**SUSTAINABLE  
DEVELOPMENT  
DIRECTORATE**

**ORDINARY COUNCIL  
MEETING**

Wednesday, 23<sup>rd</sup> of November 2022  
Commencing at 5.00pm

## SHIRE OF DARDANUP LOCAL PLANNING SCHEME No.3 AMENDMENT No. 205

Figure 14

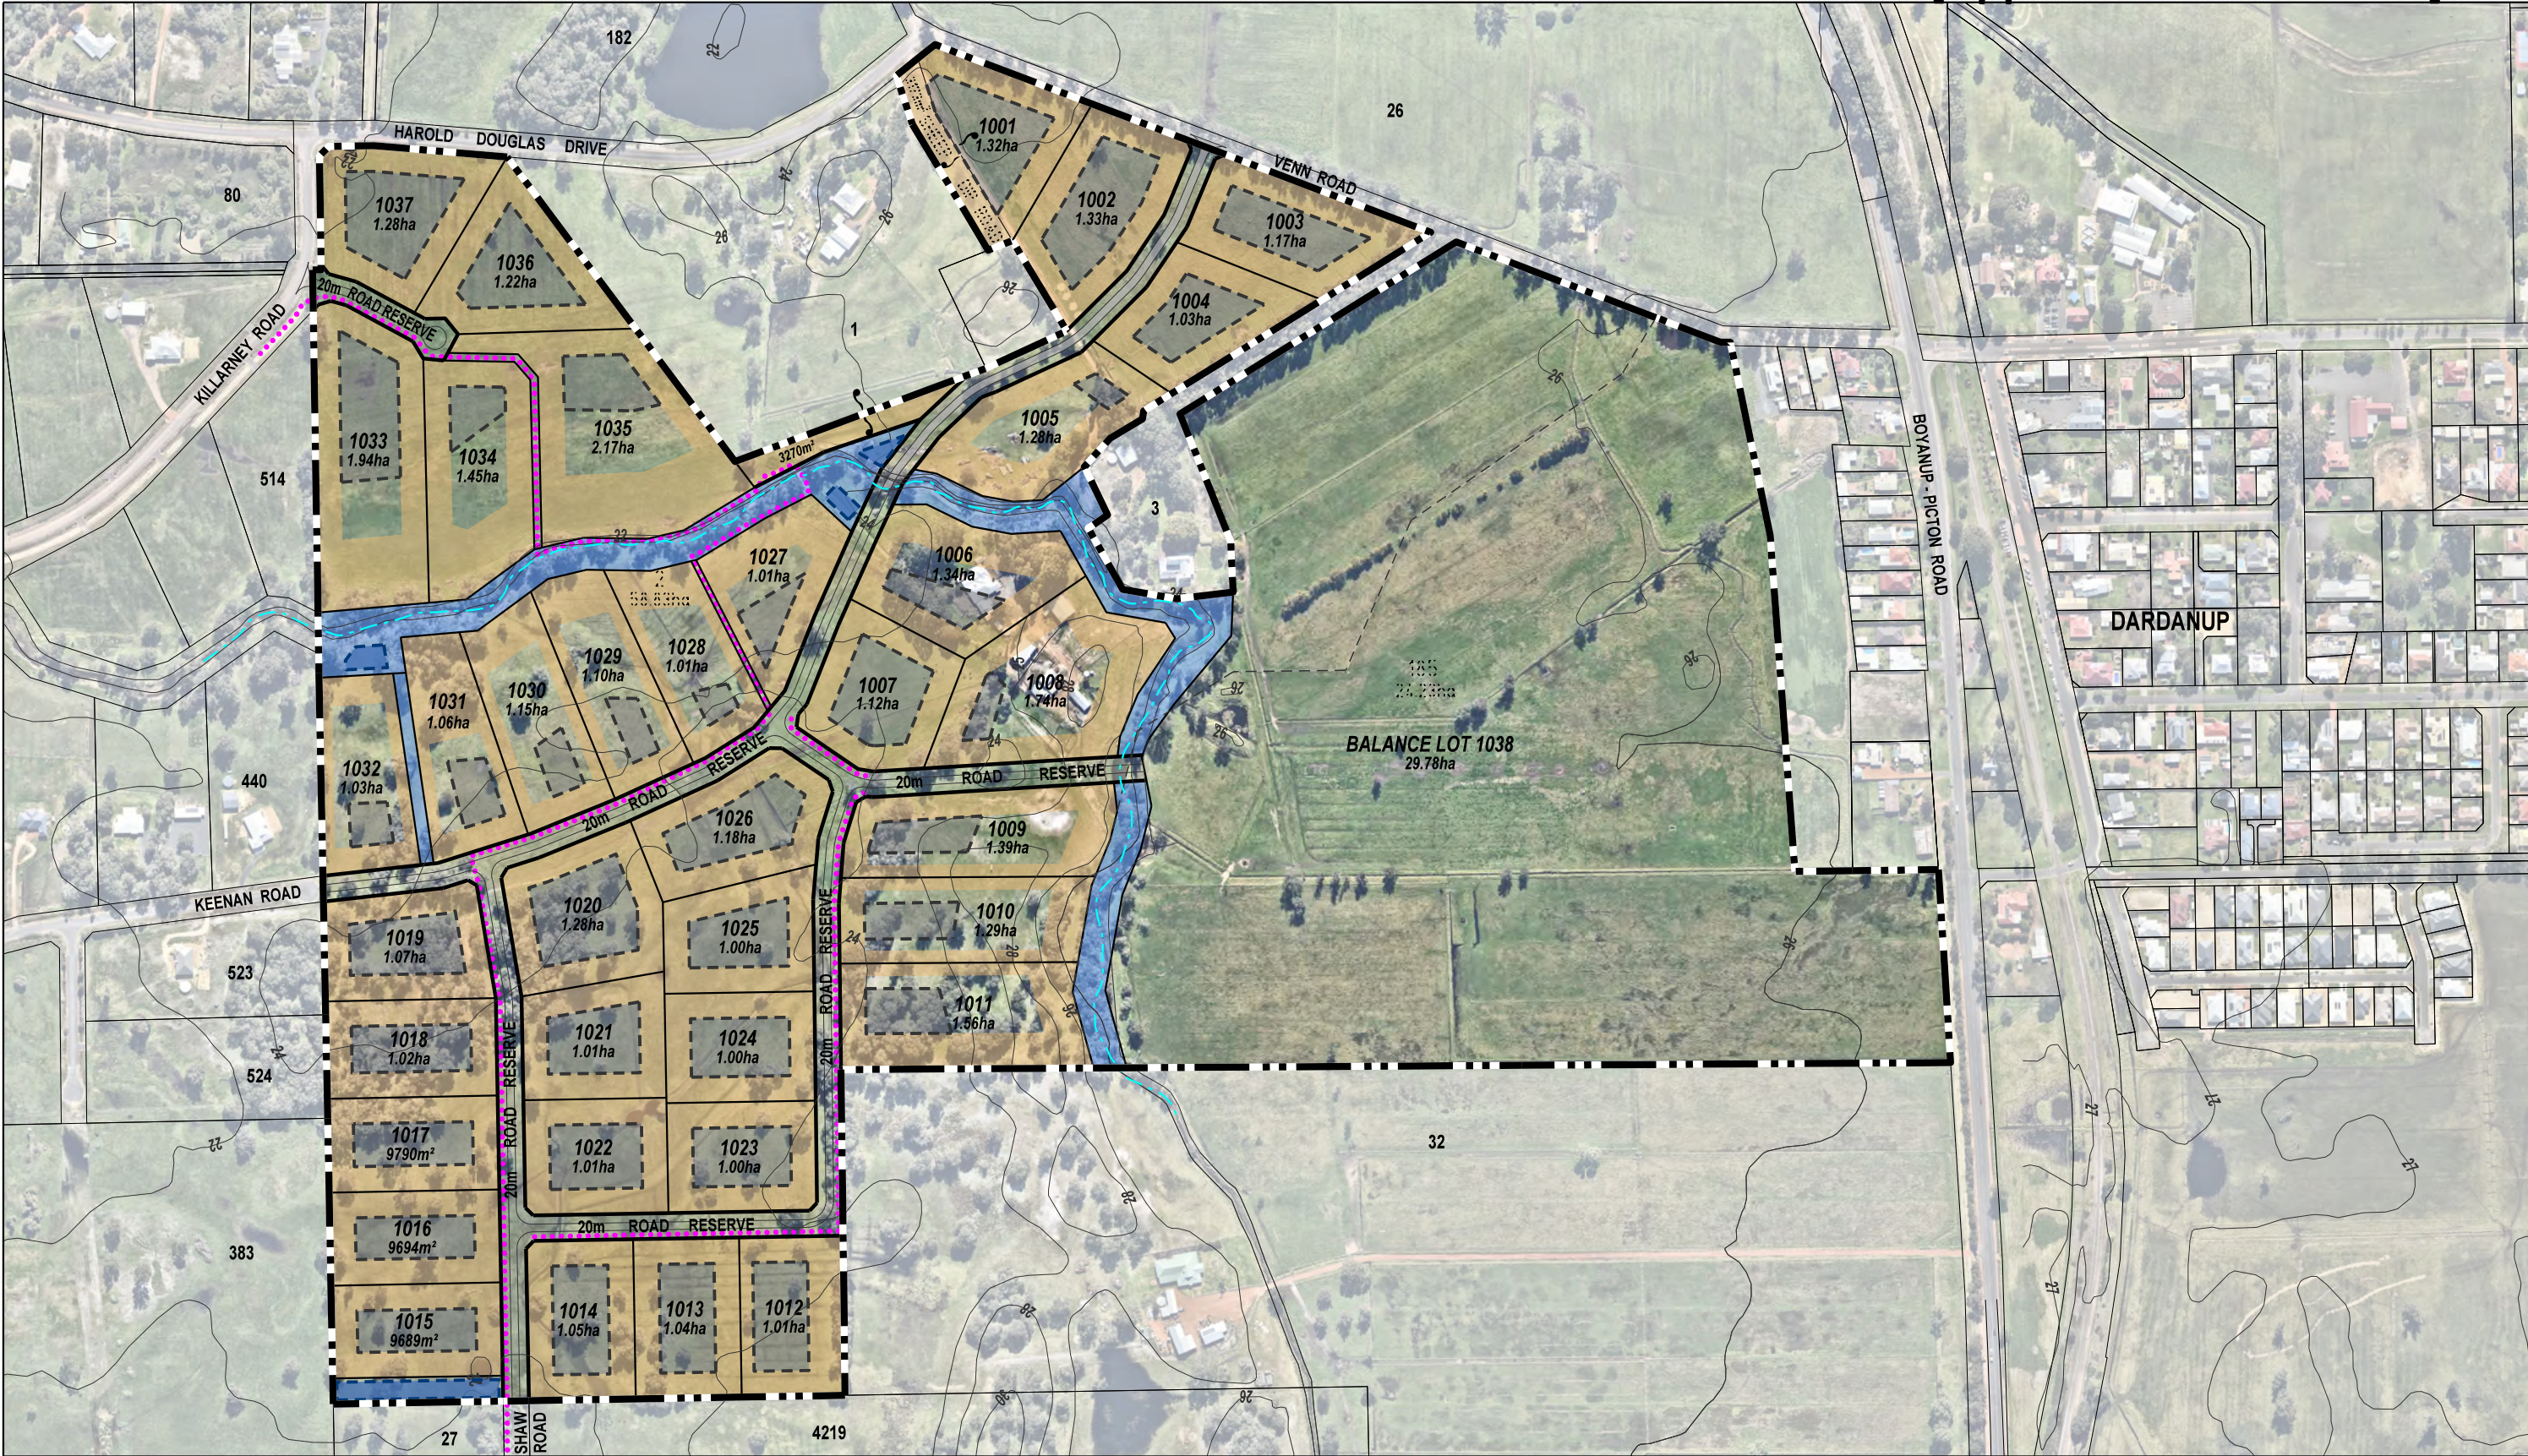
9. The applicant acknowledges that the eventual small holdings lot layout will be determined at the subdivision approval stage.
10. Accordingly, the applicant recommends that the preliminary subdivision 'Concept Plan' (Figure 14) be replaced with a new Concept Plan (see **attached**) that demonstrates:

Figure 16: Clearing and revegetation

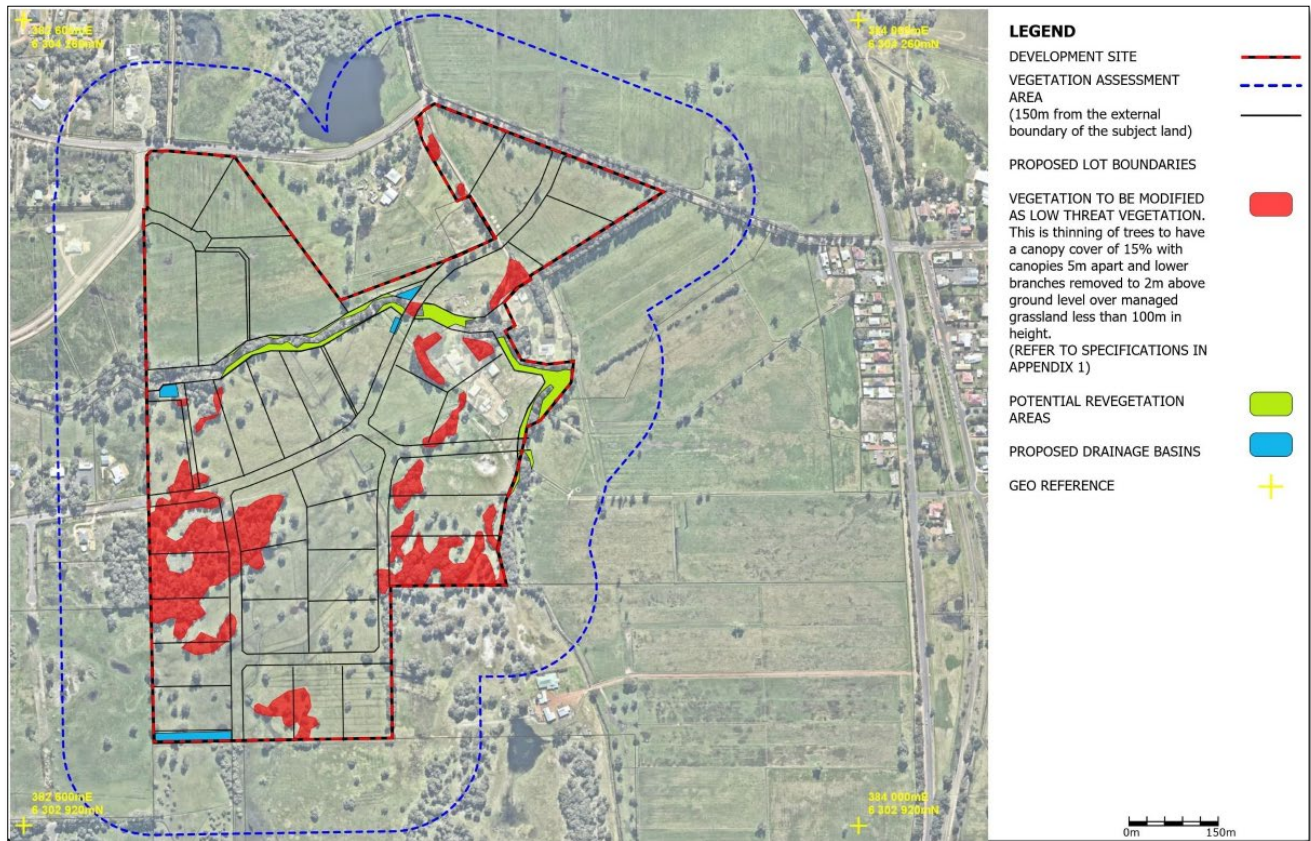
Scheme Amendment document (Across Planning March 2022) section 7.13 (Environmental Management) and Figure 16 refer to revegetation within Gavin's Gully reserve. The Environmental Report Figure 4 (Possum Observations) found WRP within native vegetation associated with Gavin's Gully. DBCA supports revegetation with local endemic species within Gavin's Gully reserve, to enhance the fauna corridor.
